Model: Evora Model Range
from '18 Model Year VIN JHB20905 to
JHA11273

Number: 2018/01R
Federal & Canadian
Markets

Re-torque of the steering column cartridge screw.

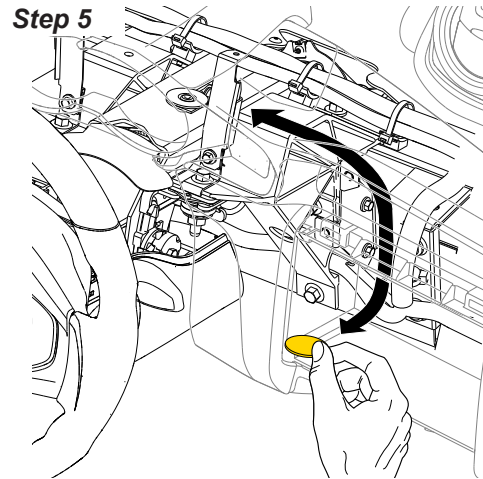
5. Place a hand through the unit aperture and route it towards the top of the steering column, feel for the self adhesive protective patch, remove and retain for refitment.

Note: it is possible that the patch is obscured by harness wiring, take care not to use excessive force when moving the wiring, as this may cause damage to harness and connector plugs.

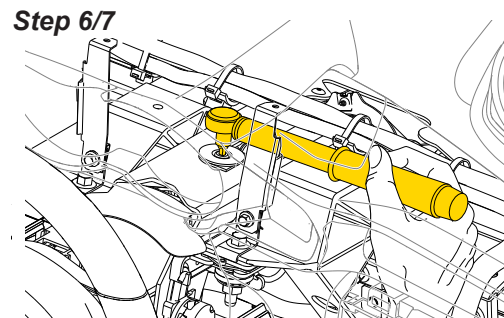
6. Using the 5mm Allen socket provided and a suitable ¼ inch drive torque wrench, pass it through the audio unit aperture, guiding the Allen socket onto the head of the column cartridge screw.
7. Tighten the screw to 5 Nm, (if the screw was loose, then up to ½ turn will be required to achieve the required torque figure).
8. Remove the torque wrench and refit the self adhesive protective patch onto the steering column over the top of the column cartridge screw.

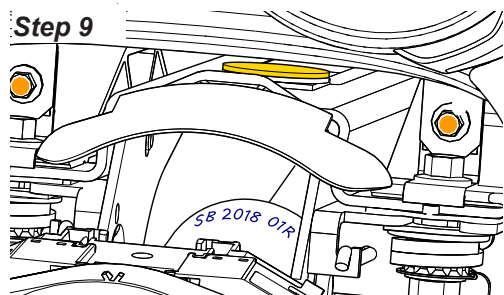
9. Using a suitable marker pen, write the recall campaign number (2018/01R) on the top of the ignition barrel/lock housing.
10. Refit all ancillary components previously removed.
